PROPOSED TECHNICAL SPECIFICATION CHANGE

SURRY POWER STATION
UNIT NOS. 1 AND 2

ATTACHMENT 2

SAFETY EVALUATION

Figure 6.1-1 Offsite Organization for Facility Management and Technical Support

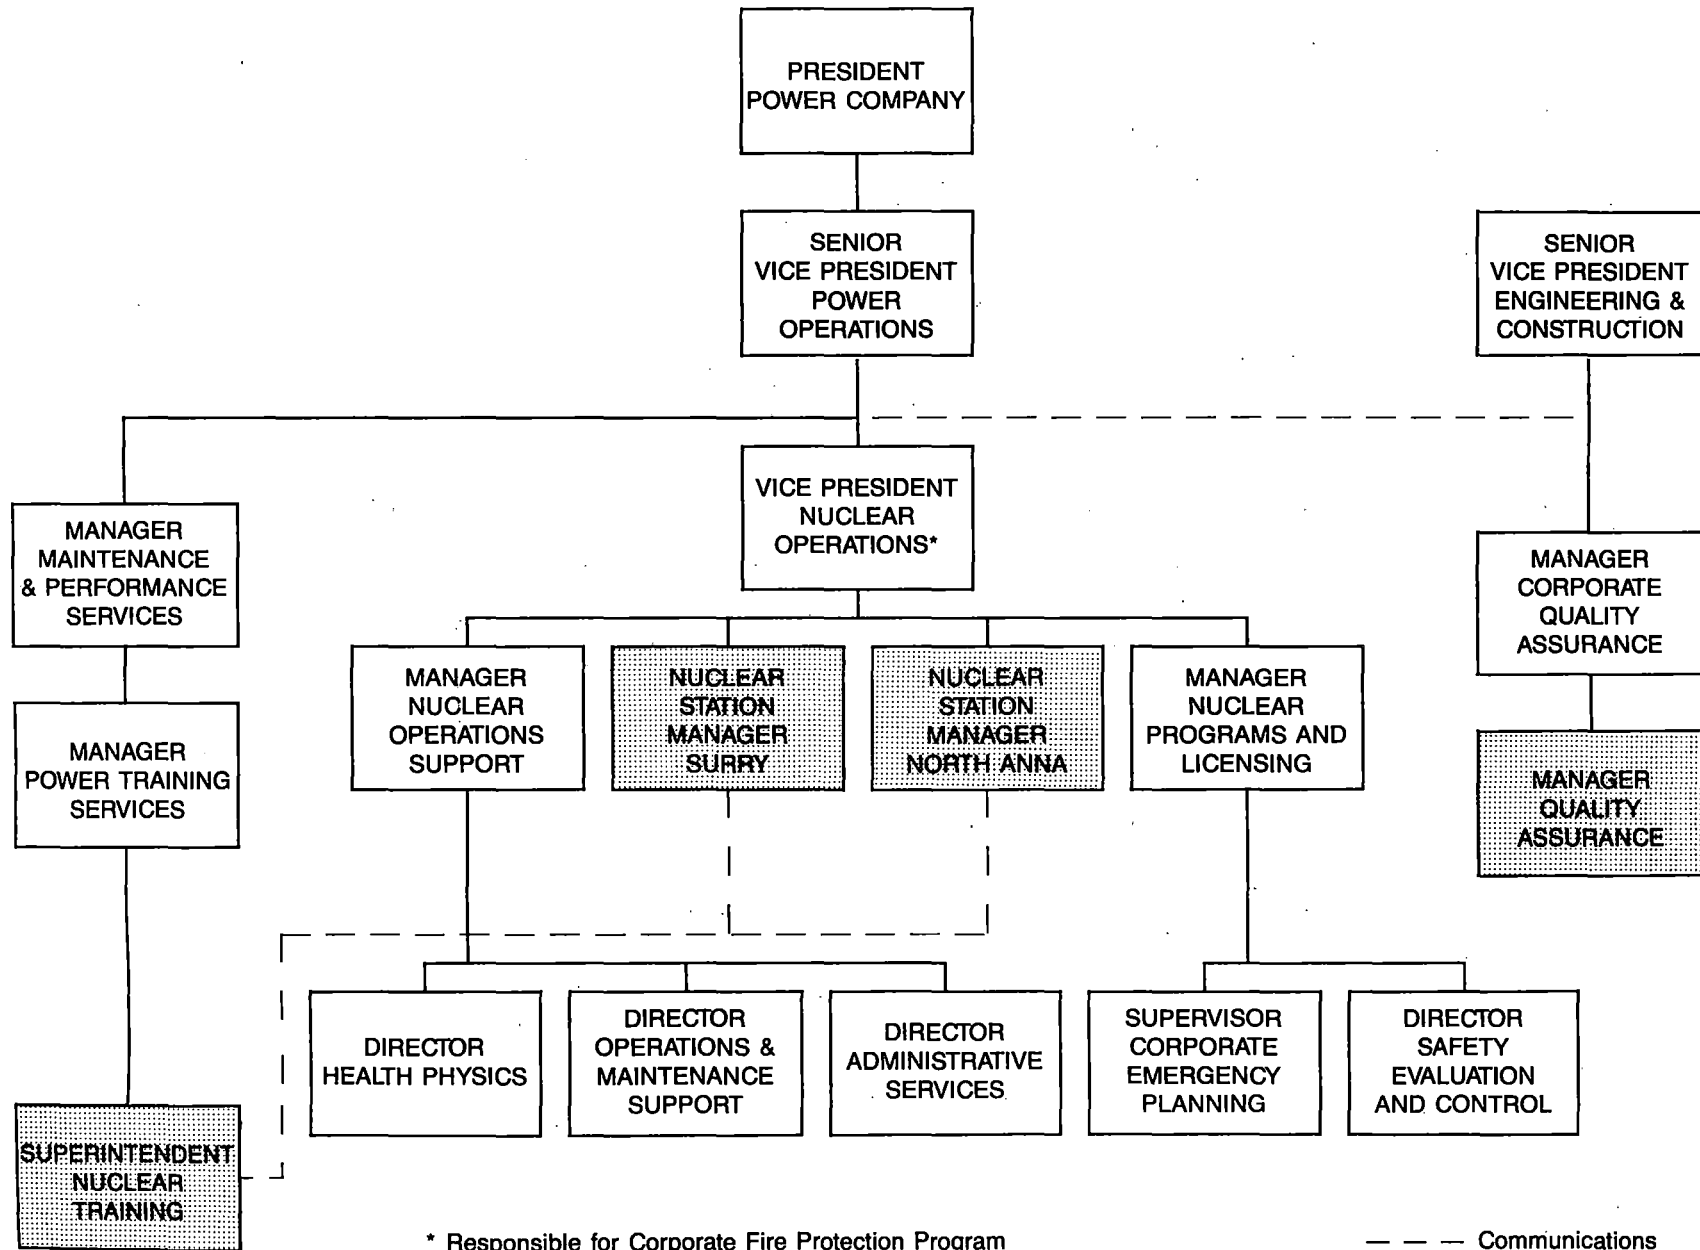
This proposed change will modify Section 6 of the Surry Technical Specifications to reflect a company reorganization in which the Quality Assurance organization will now report to the Senior Vice President - Engineering and Construction, rather than the Senior Vice President - Power Operations. It also changes the titles of several on-site and off-site managers and supervisors, and deletes the Director, Nuclear Training. As the major emphasis of the Company's nuclear program is on operations rather than construction, it is appropriate that the QA organization report to Engineering and Construction to enhance the independence of the QA organization.

- (1) involve a significant increase in the probability or consequences of an accident previously evaluated. This change merely revises where the QA organization reports to enhance independence and corrects titles in the on-site and off-site organization charts. Thus, this change does not change plant design or operation and does not increase the probability or consequences of an accident.

Figure 6.1-2 SURREY POWER STATION ORGANIZATION CHART

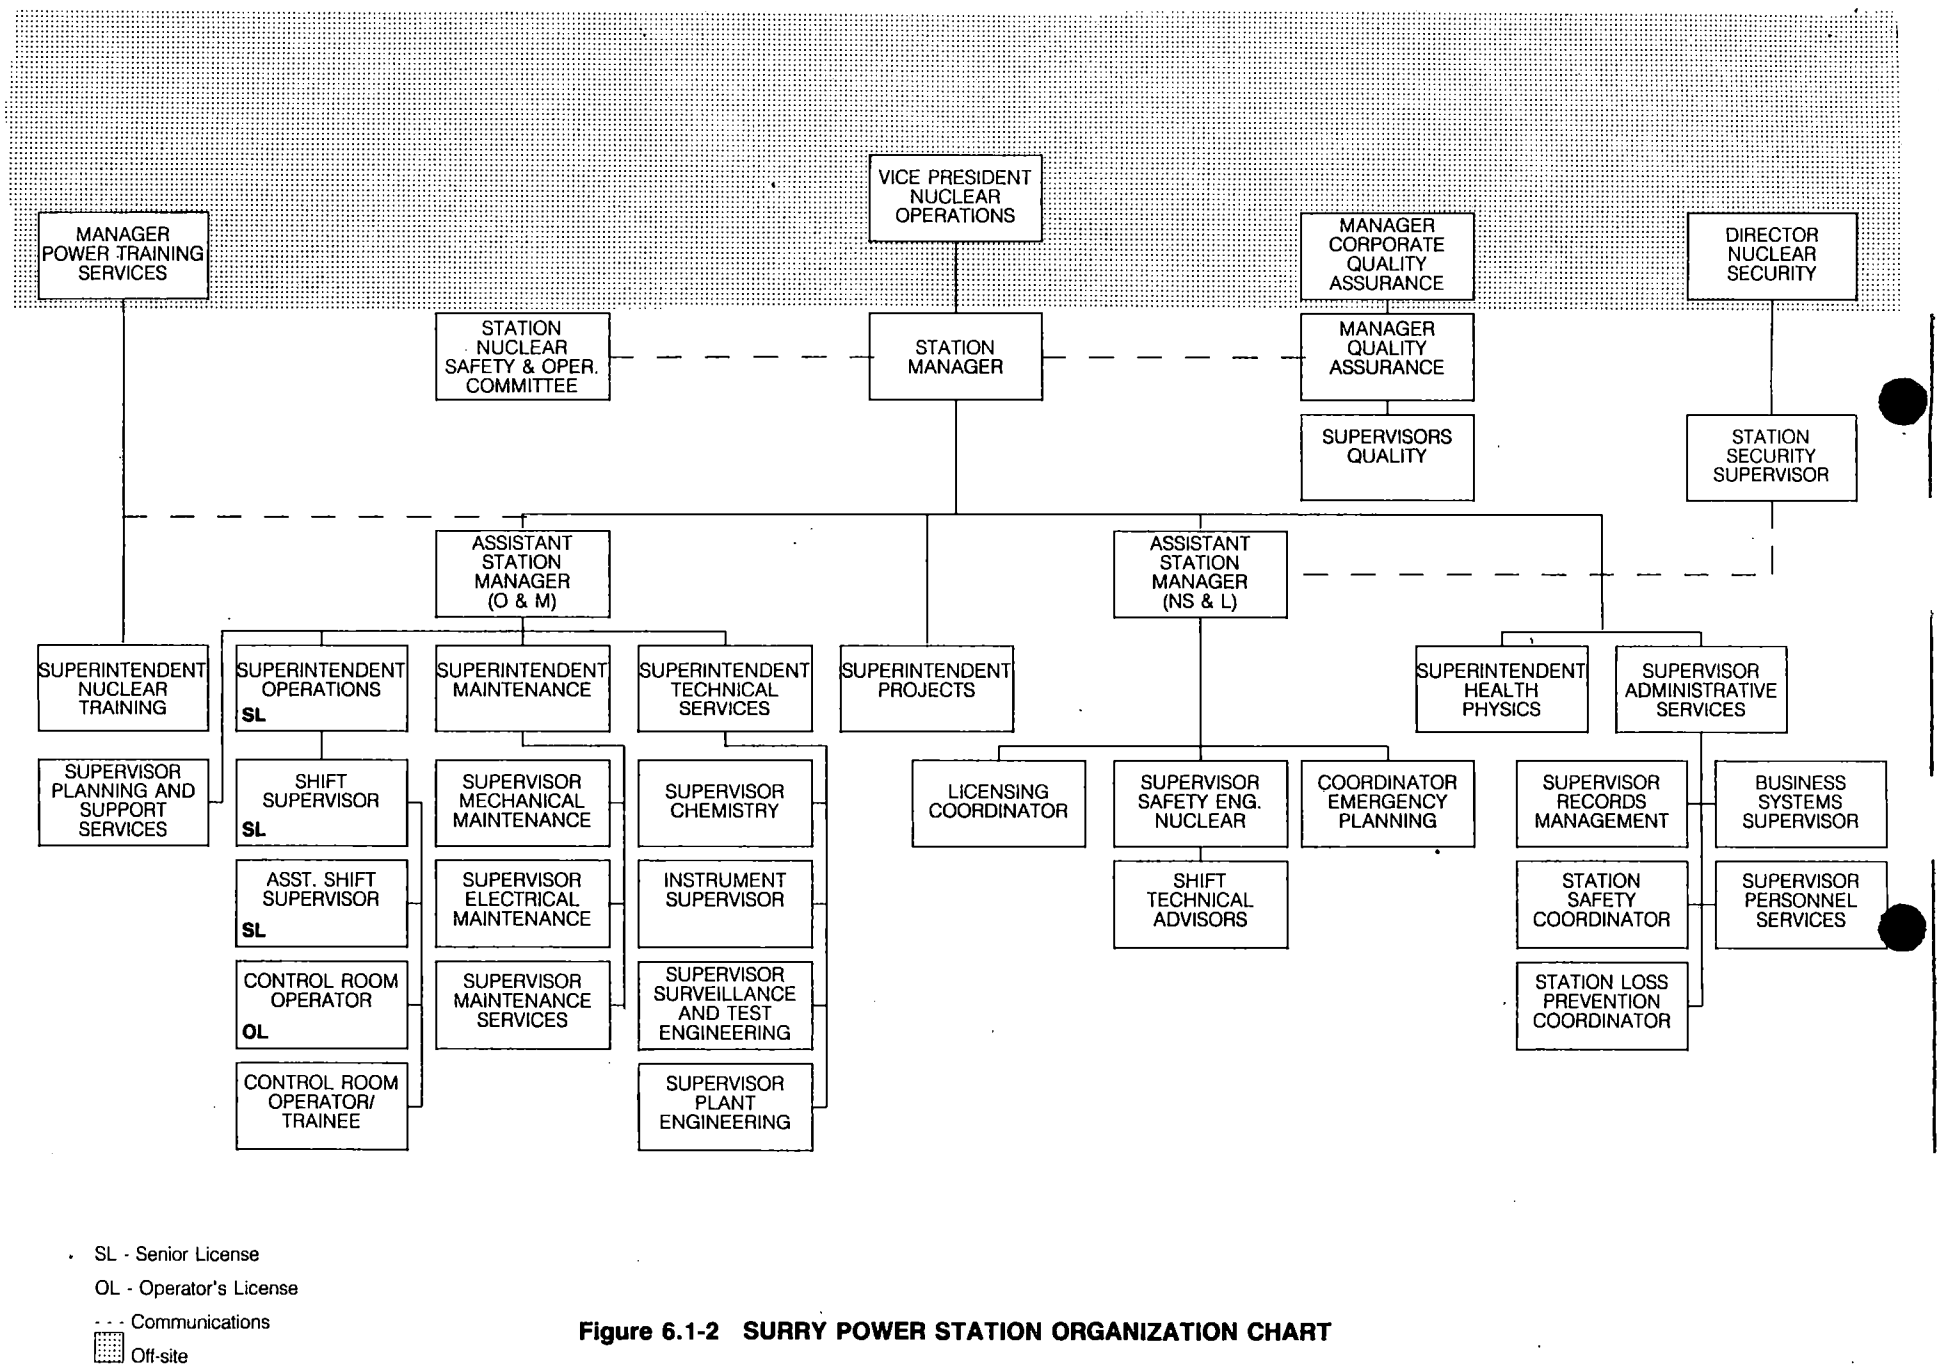
- (2) create the possibility of a new or different kind of accident from any previously analyzed. It has been determined that a new or different kind of accident will not be possible due to this change. Realigning the QA organization with Engineering and Construction, revising supervisor or manager titles or deleting the Director, Nuclear Training position do not create the possibility of a new or different kind of accident.
